APPLICATION NO.	FILING DATE	FIRST NAMED INVENTOR	ATTORNEY DOCKET NO.	CONFIRMATION NO.
10/600,939	06/20/2003	Jeffrey P. Whittemore	ZIP-0007	9441

Office Action Summary

DETAILED ACTION

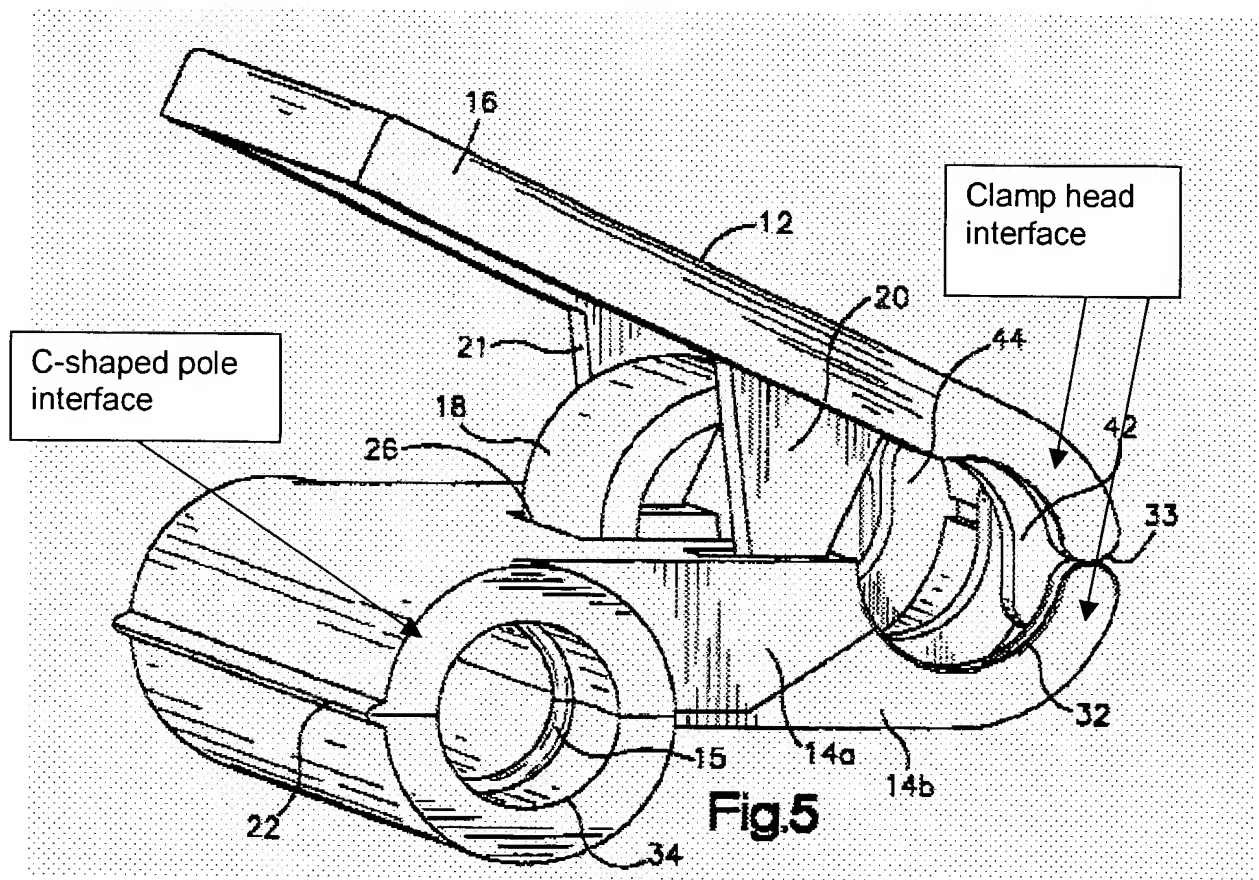
Claims 1-5, 11, 14, 19, 20, 24-26, 30-33, 39, and 45 are rejected under 35 U.S.C. 102(e) as being anticipated by Lassiter (US patent no. 6,523,231). Lassiter discloses a mount assembly comprising a pole interface (see below illustration) coupled to a mount body via hinge (22), the pole interface capable of interfacing with a side portion of a pole; a head interface (12 and 14) coupled to the mount body; a biasing unit (18) for outwardly biasing the pole interface and head interface with respect to each other; wherein the pole interface is at a first end of the mount body and wherein the head interface is at a second end of the mount body; the pole interface comprises a C-shaped body; wherein the pole interface comprises a non-skid material (50, figure 10); wherein the head interface comprises a clamp (12 and 14) that is capable of coupling the partition mount to a head; wherein the head interface is integral with the mount body; wherein the biasing unit is a spring outwardly biased; wherein the mount body is made of plastic.
